Access Compliance Report

Public Rights-of-Way

Intersection ID: 10140	Main Street: E_36TH_ST	Cross Street: N_ALEXANDER_ST	Location: E
ADA ID: 9D877A43893F	Ramp Type: PerpDiag	Initial Pass/Fail: Fail	Overall Compliance: No
		Severity Score: 12.5

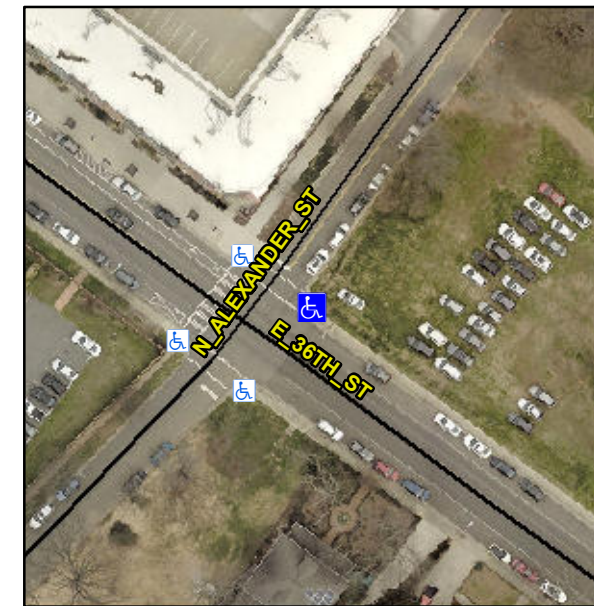
Not Found, R304.5.3

Compliance	Description	Data	Compliance	Description	Data
N/A	Ramp Length (in)	48.0	Yes	Ramp Slope (%)	7.9
Yes	Ramp Width (in)	48.0	No	Ramp XSlope (%)	5.1
N/A	Flare Type LT	N/A	N/A	Flare Type RT	N/A
N/A	Flare Slope LT (%)	N/A	N/A	Flare Slope RT (%)	N/A
N/A	Flare Traversable LT?	N/A	N/A	Flare Traversable RT?	N/A
N/A	Landing Length (in)	N/A	N/A	DWS Provided?	N/A
N/A	Landing Width (in)	N/A	N/A	DWS Contrast?	N/A
N/A	Landing Slope (%)	N/A	N/A	DWS Length (in)	N/A
N/A	Landing X Slope (%)	N/A	N/A	DWS Full Width?	N/A
N/A	Landing Curb? (Y/N)	N/A	N/A	DWS Offset (in)	N/A
N/A	Shared Landing?	N/A			
N/A	Gutter Ponding?	N/A	N/A	Gutter Slope (%)	N/A
N/A	Gutter Lip Ht (in)	N/A	N/A	Gutter X Slope (%)	N/A
N/A	Painted X Walk1?	Yes	N/A	Painted X Walk2?	No
	X Walk 1 Direction	To NW		X Walk 2 Direction	To SW
N/A	X Walk 1 Width (in)	102.0	N/A	X Walk 2 Width (in)	N/A
	X Walk 1 Slope (%)	2.3		X Walk 2 Slope (%)	5.8
	X Walk 1 X Slope (%)	8.1		X Walk 2 X Slope (%)	0.5

Remove & Replace Curb Ramp With Two New Directional Ramps or Equivalent.
